DBP Transmission: Dampier Bunbury Natural Gas Pipeline

REVIEW OF SELECTED ASPECTS OF REVISED FINAL PLAN FOR AA5 (2021 TO 2025)

Report prepared for:
**ECONOMIC REGULATION
AUTHORITY OF WESTERN
AUSTRALIA (ERA)**
December 2020

Figure 4.2: DBP's historical and forecast annual number of DBNGP fleet vehicle replacement

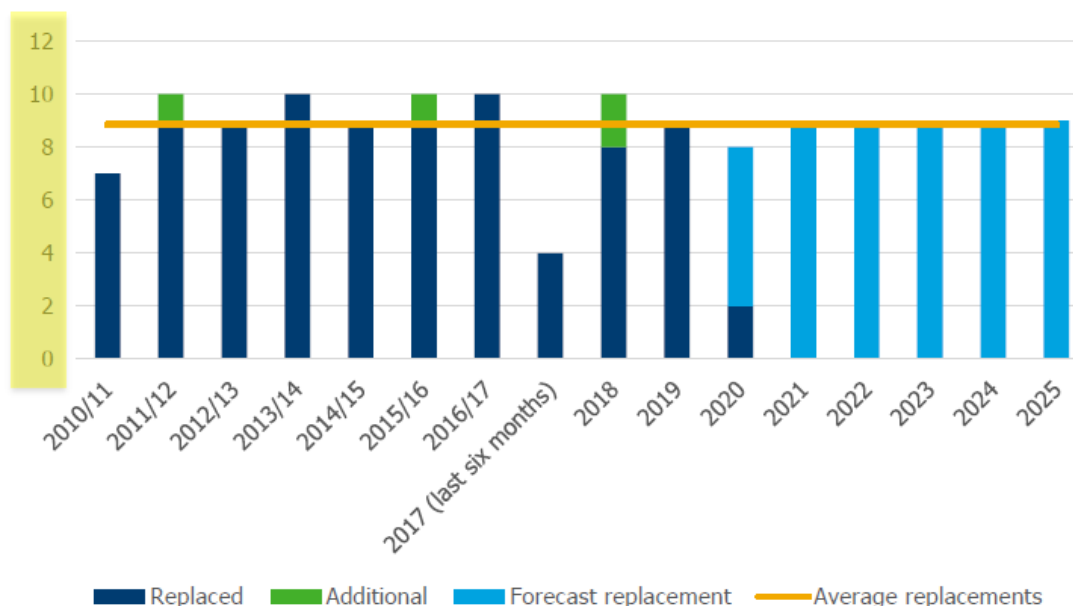
189. We are satisfied with the analysis to support DBP's assertion that the long run average replacement rate is [REDACTED] vehicles p.a.

Figure 4.5: IT Enabling – NPV sensitivity analysis – DBP model, \$k, June 2019

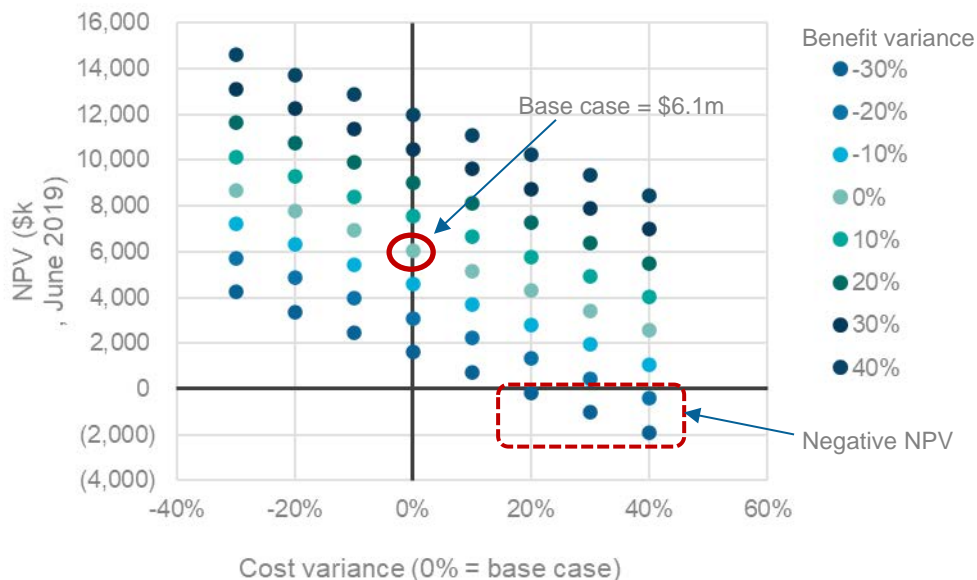
270. DBP’s model exhibits a reasonably robust outcome. However, as discussed below, we have issues with DBP’s model.

Figure 4.6: IT Enabling – cumulative cashflow for DBP model and with adjusted assumptions

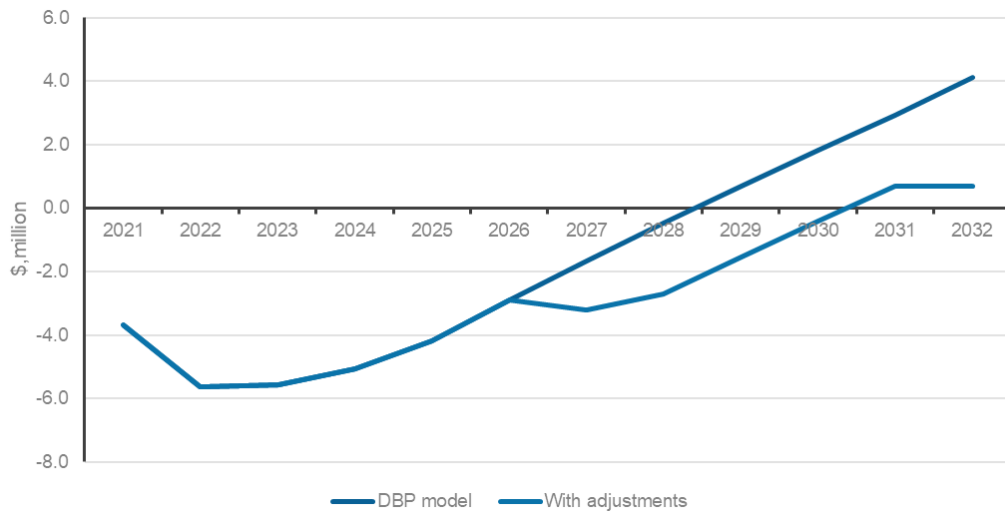
276. These changes reduce the \$6.1m NPV derived from DBP's model to \$0.7m. The impact on cumulative cash flow is shown in Figure 4.6 below. The breakeven year is delayed from DBP's 2029 to 2031 with the adjusted assumptions, and the IRR is reduced to 4.9% from DBP's modelling result of 13.8%. We consider these two key indicators indicate that the investment is unlikely to be prudent.

Figure 4.7: IT Enabling - NPV sensitivity analysis – with adjustments, \$k, Jun 2019

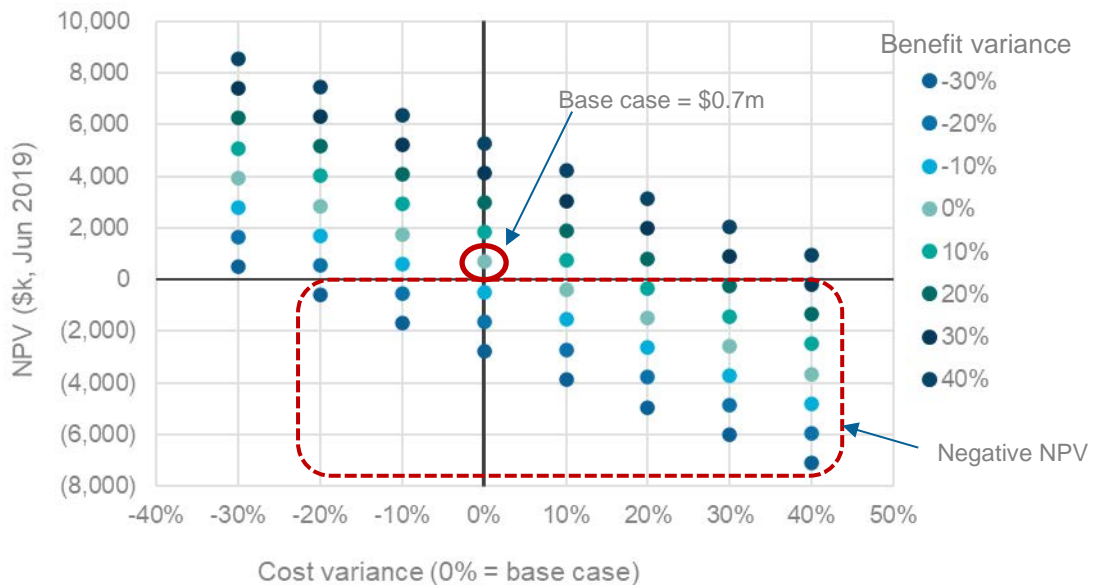
277. As a further test of the robustness of the positive NPV, we assessed the sensitivity of the EMCa-adjusted matched-period assumptions to variances in cost (capex and opex) and benefit. The figure below shows the NPV sensitivity study results using the EMCa-adjusted assumptions. Even a 10% increase in cost, with no change in assumed benefits, results in a negative NPV. Compared to the results from DBP’s model, the NPV would be negative for a large number of unfavourable cost and/or benefit variances.

Figure 6.1: Combined delivered price of hydrogen/renewables versus gas (incl transport and storage)

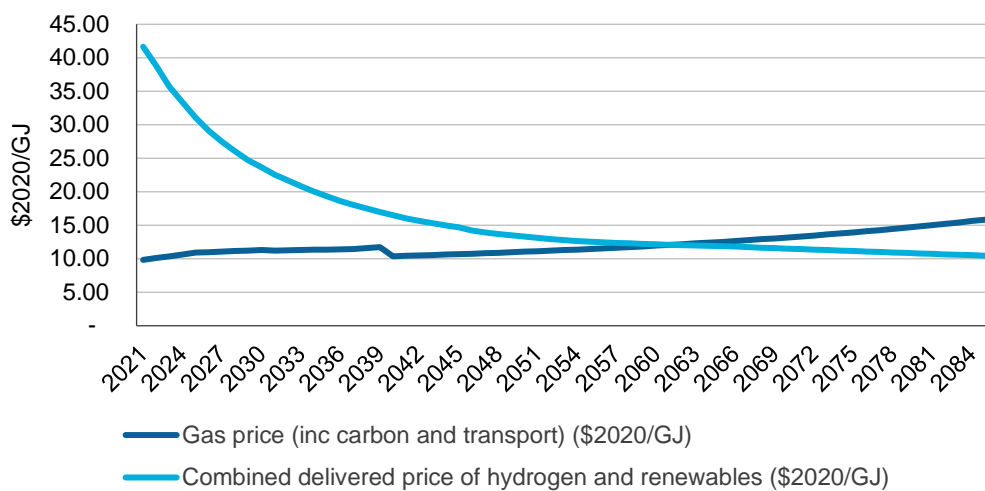
405. While we observe a cross-over point from around 2063, the shallow slope of both lines shows the significant sensitivity of that date to relatively minor changes in assumptions. While industry forecasters would tend to agree on an increasing cost for gas and a decline in the cost of alternatives, the point of cross-over is extremely sensitivity to the respective rates of increase and decline.

Figure 6.2: Components of ACIL gas price forecast

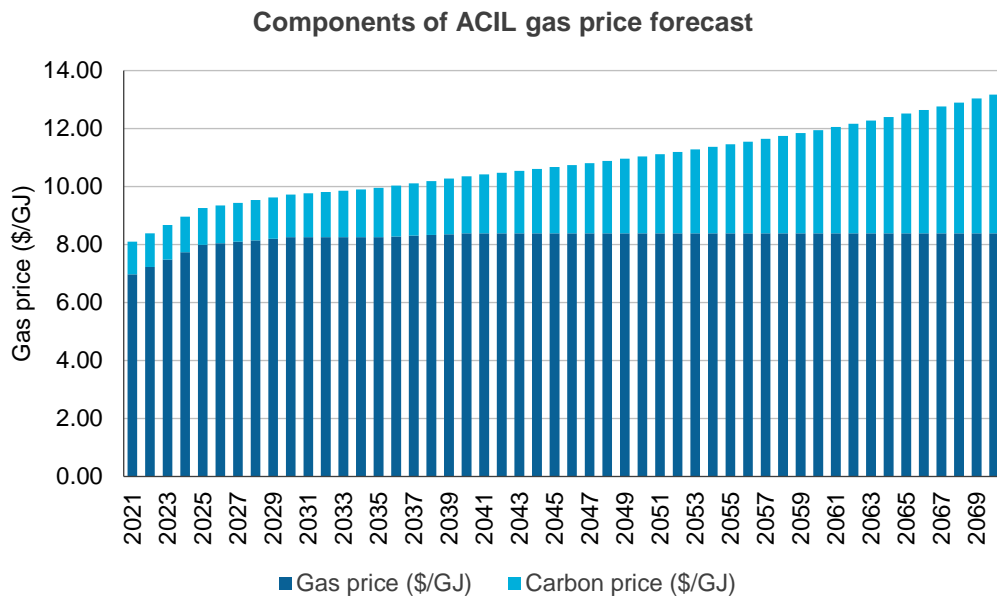
408. The sensitivity of the finding that 2063 represents a reasonable assessment of the economic life of the DBNGP is apparent from observation of this forecast together with the shallow inferred cross-over between gas and alternatives in Figure 6.1. As can be seen from Figure 6.2, the sole driver for the assumed increase in the gas price is the forecast increase in the 'carbon price' component. A relatively small reduction, for example, in the assumed slope of increase of the forecast carbon price would defer the cross-over by many years.
